UNITED STATES PATENT AND TRADEMARK OFFICE

APPLICATION NO.	FILING DATE	FIRST NAMED INVENTOR	ATTORNEY DOCKET NO.	CONFIRMATION NO.
10/750,175	12/30/2003	Danh Dang	015114-069800US	5032

Office Action Summary

DETAILED ACTION

FIG. 1 (PRIOR ART)

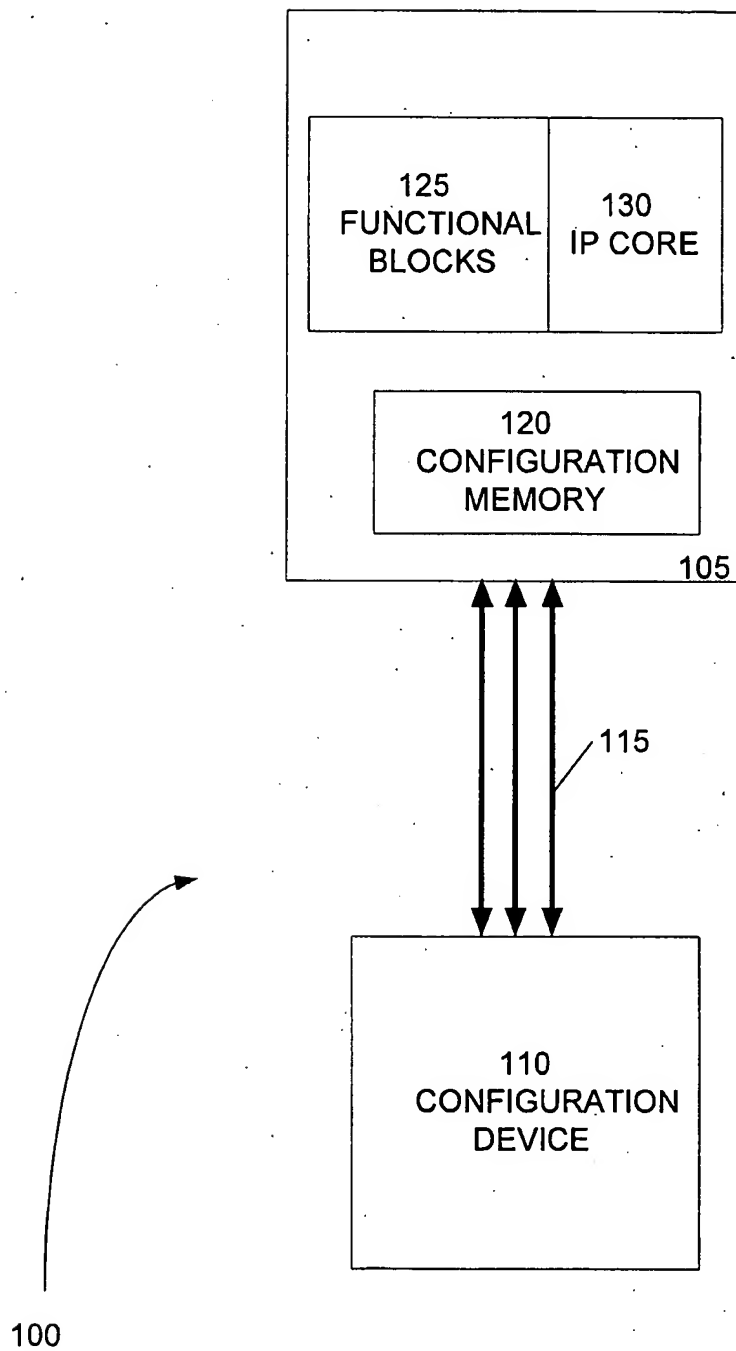
1. In view of the applicant's submission of new drawing FIG. 1, the examiner withdraws the objection to said drawing and approves the entry of FIG. 1.
2. In view of the applicant's amendments to claims 8 and 13, the examiner withdraws all objections to the said claims.
3. In view of the amendments to claims 8-10 and 11, the examiner withdraws the rejections of said claims under 35 USC 112 second paragraph.
4. In view of the amendment to claim 15, the examiner withdraws the rejection of said claim under 35 USC 101 as being non-statutory.
5. Applicant's arguments filed 3/19/2007 in respect to claims 1-20 have been fully considered but they are not persuasive. The applicant, in arguing the claims, has specifically cited the same limitation in each of the independent claims 1, 8 and 15, and
